SIB 63 03 25

DELIVERY STOP: LOW BEAM HEADLIGHT ADJUSTMENT

This Service Information Bulletin (Revision 1) replaces SI B63 03 25 **dated June 2025**.

Driver's side unit shown, looking downwards.

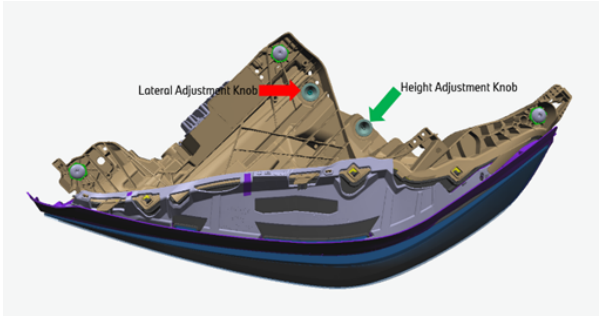
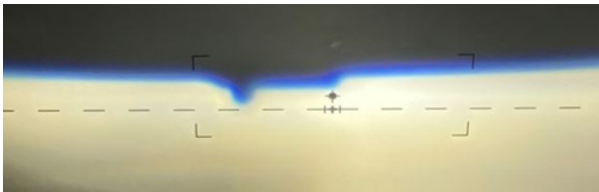
Photo is showing two adjusting knobs but **ONLY** the height adjustment knob (green arrow) needs to be adjusted.

Note: There is no need to adjust the lateral adjustment knob (red arrow).

2. Remove the locking pin inside the height adjusting knob and rotate the height adjustment knob counterclockwise (CCW) so that the light pattern of the headlight is higher than the horizontal target line.

3. Rotate the height knob clockwise (CW) so that the light pattern of the headlight lines up with the horizontal target line.

4. Rotate the height adjusting knob CCW by approx. $\frac{3}{4}$ of a turn. The headlight pattern must not move when performing this step.
